Fuel cell technologies – iTeh Standards
Part 6-100: Micro fuel cell power systems – Safety
(<https://standards.iteh.ai>)
Document Preview

IEC 62282-6-100

Edition 1.0 2012-10

AMENDMENT 1

Figure E.2 – Fuel cartridge leakage and hydrogen leakage and test flow chart for vibration, drop, compressive loading – Replaces Figure 2

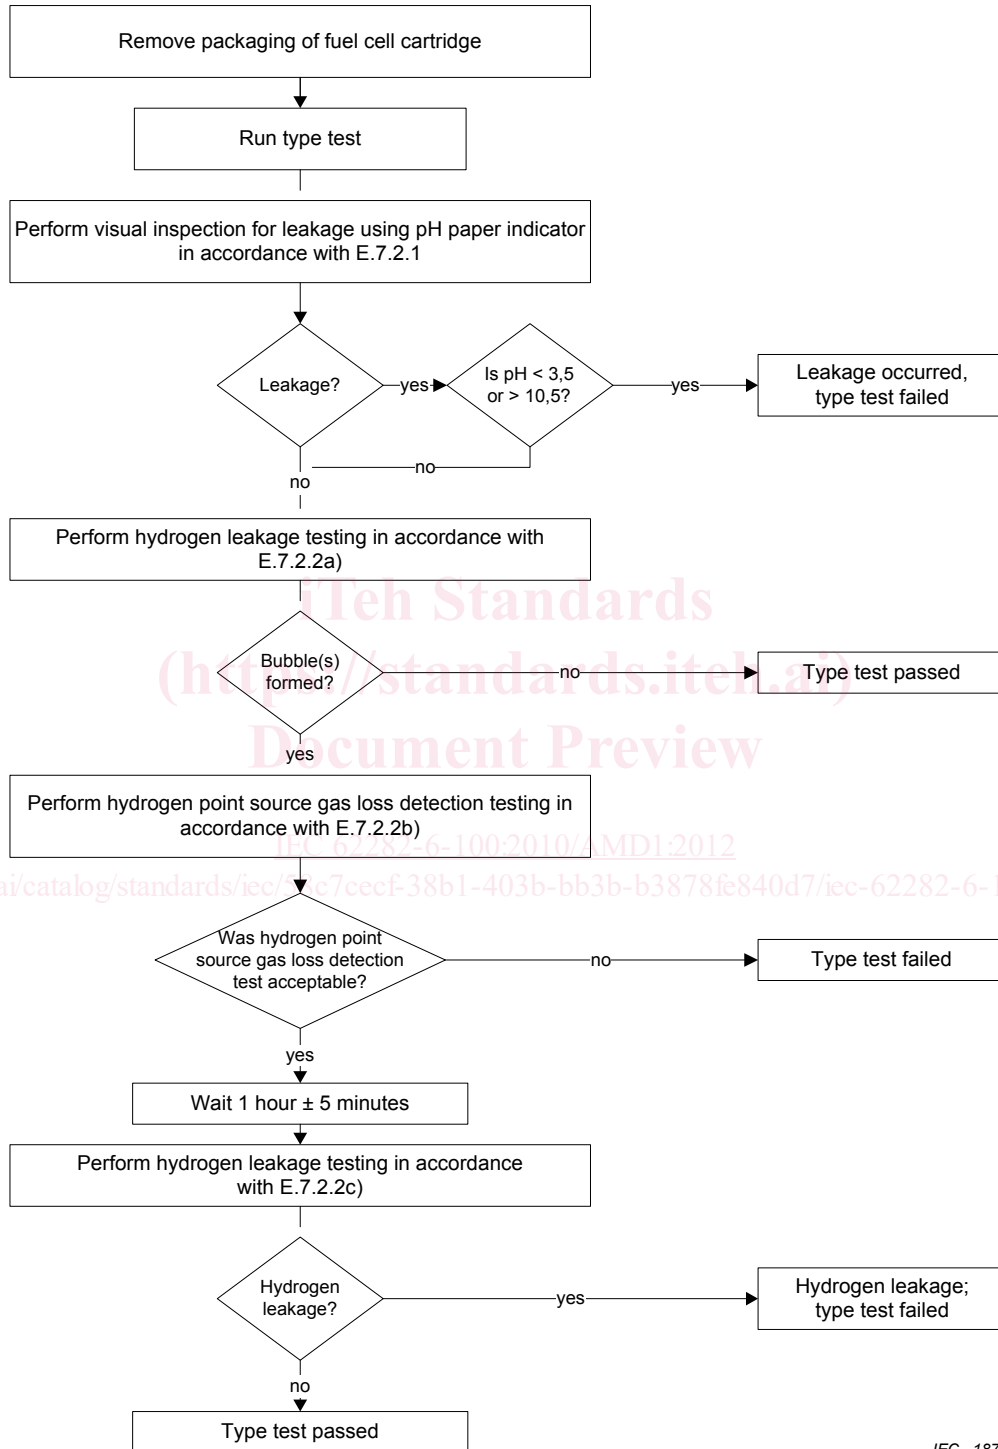
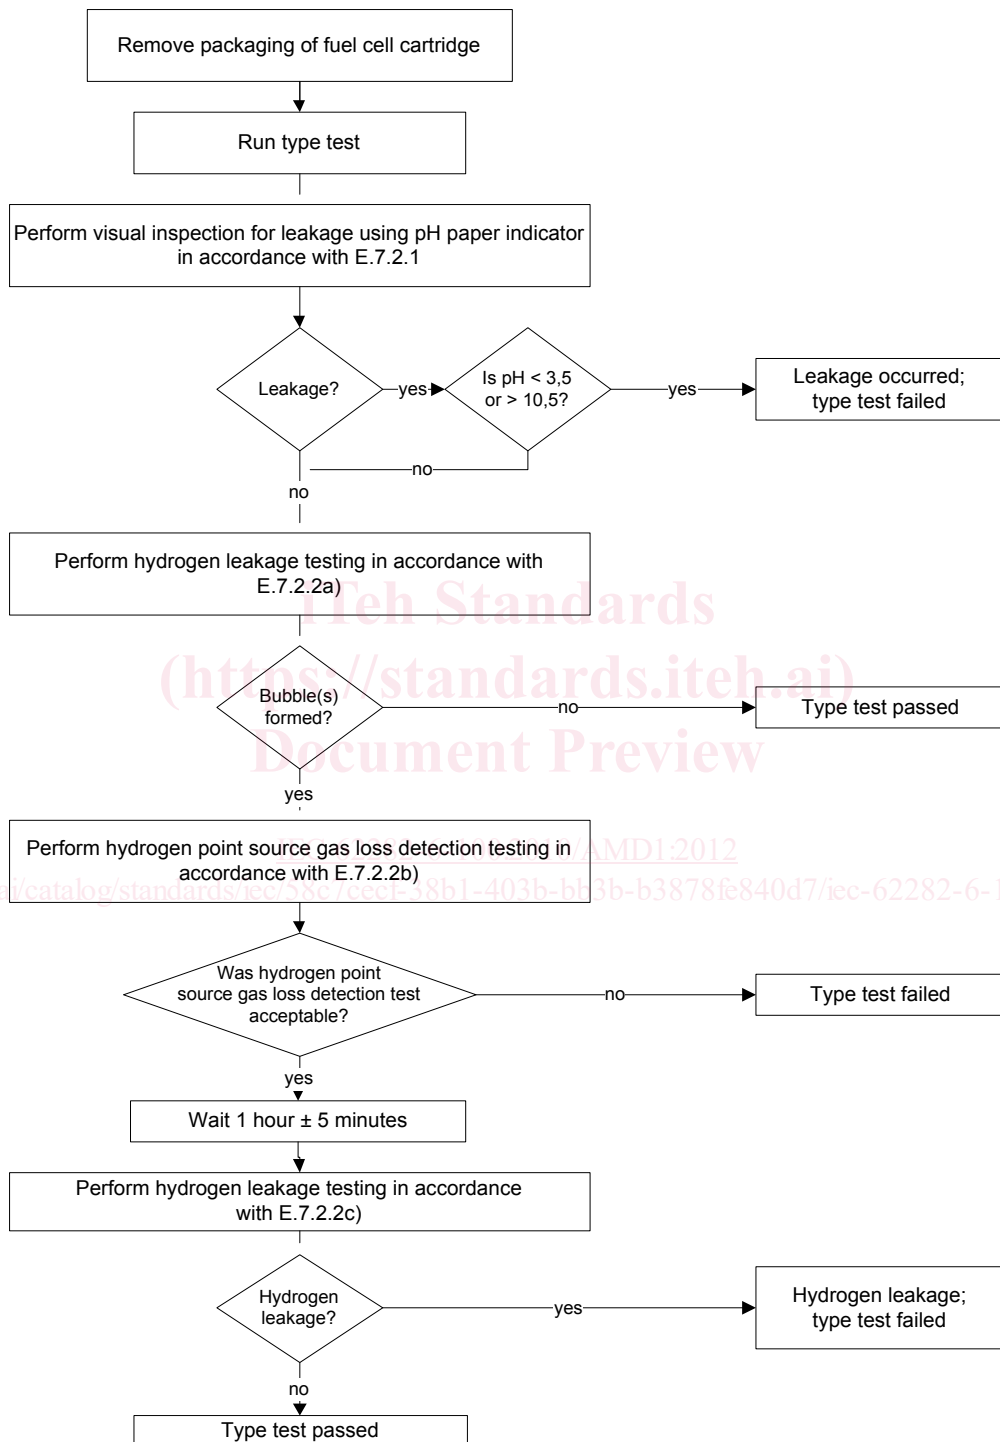
Replace the existing Figure E.2, together with its title, with the following:

Figure E.3 – Fuel cartridge leakage and hydrogen leakage test flow chart for temperature cycling test and high temperature exposure test – Replaces Figure 3

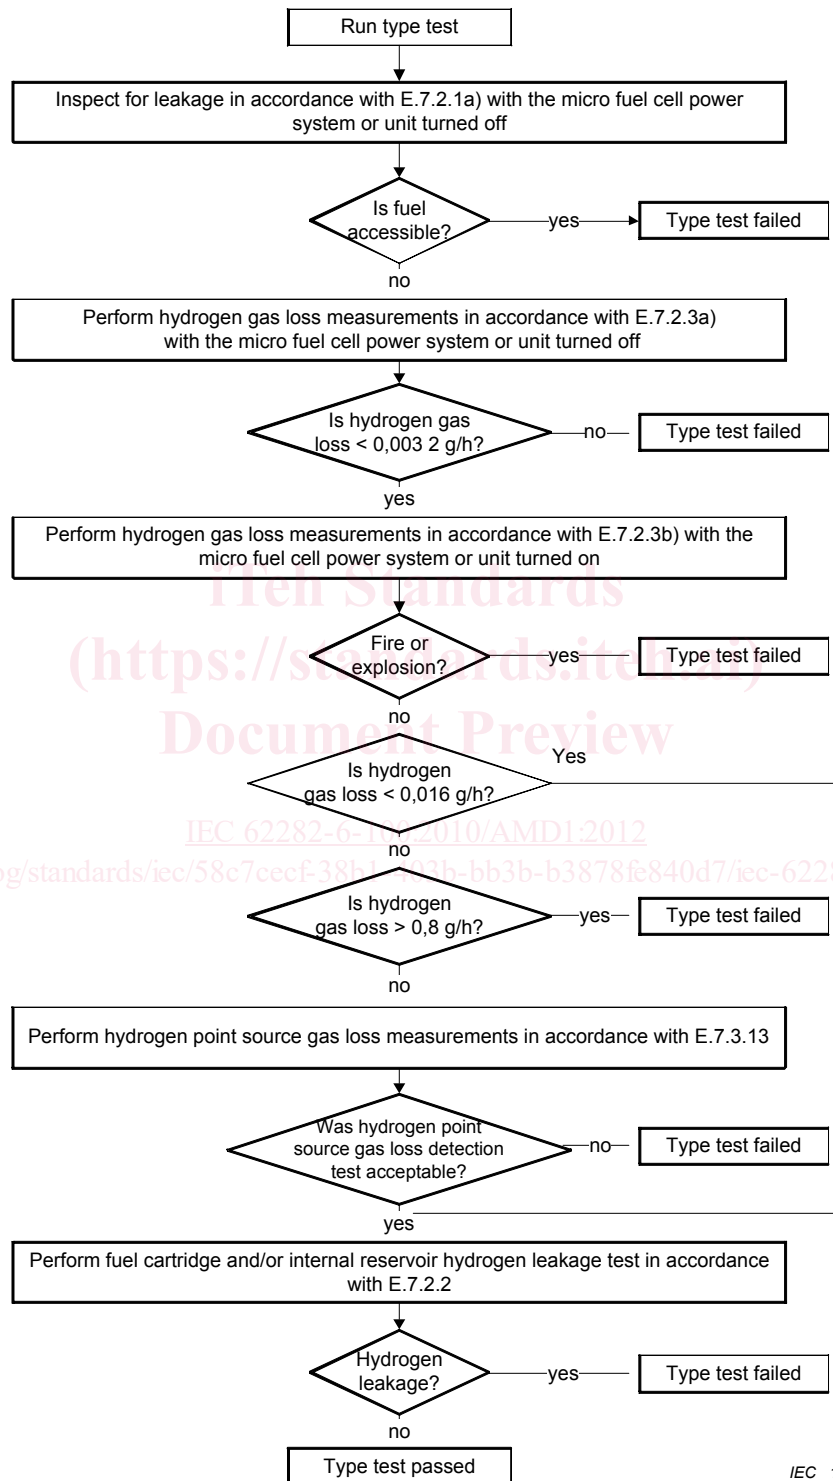
Replace the existing Figure E.3, together with its title, with the following:

Figure E.5 – Micro fuel cell power system or micro fuel cell power unit leakage and hydrogen gas loss test flow chart for external short-circuit test – Replaces Figure 5

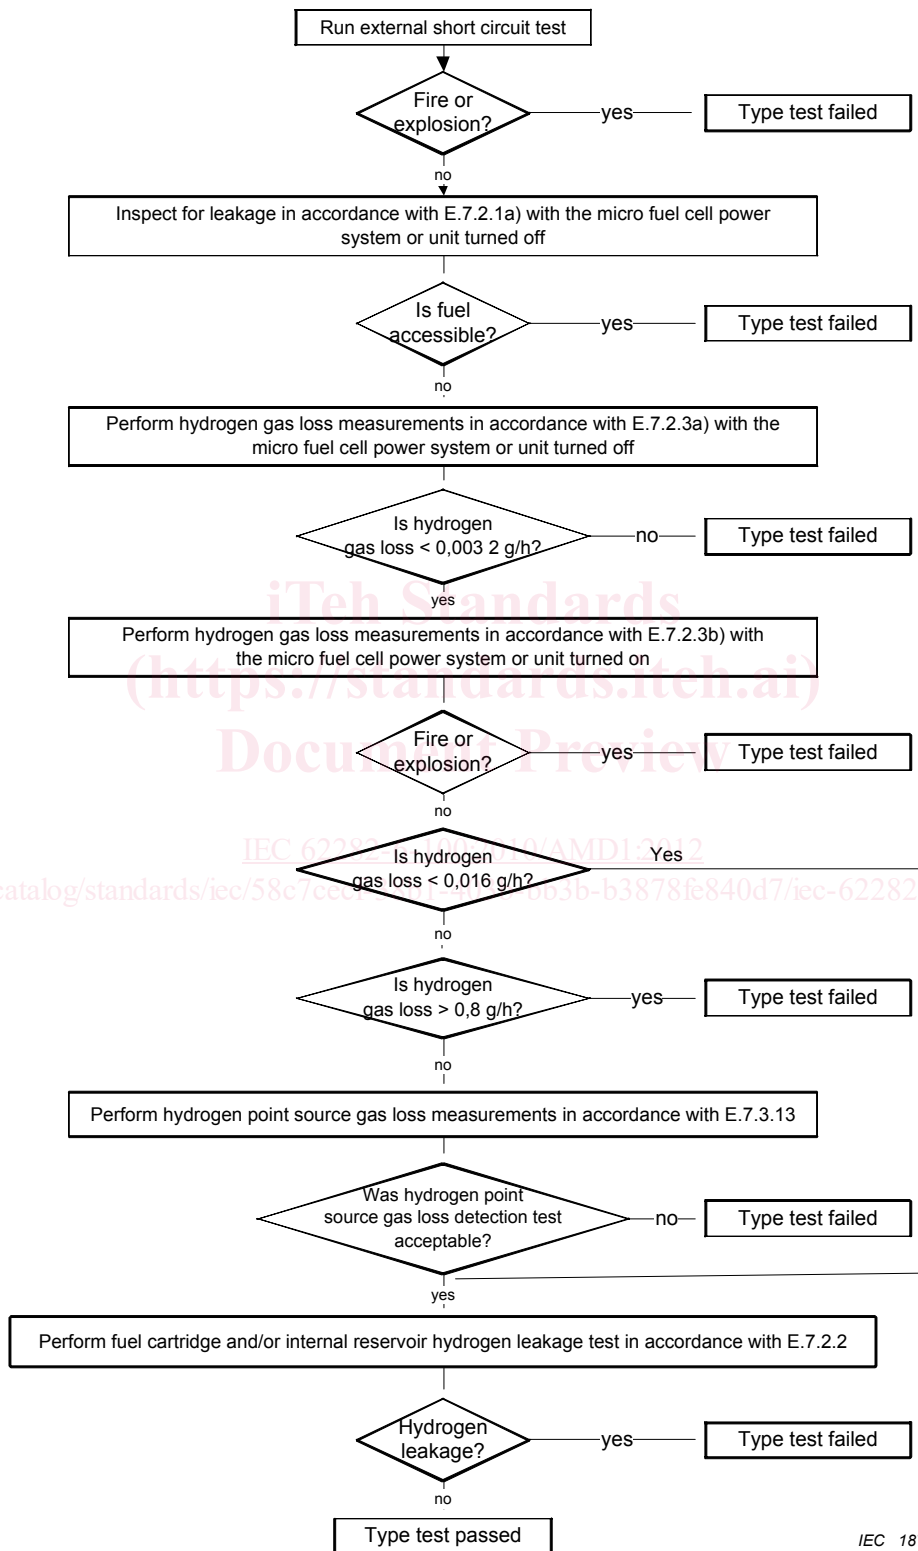
Replace, the existing Figure E.5, together with its title, with the following:
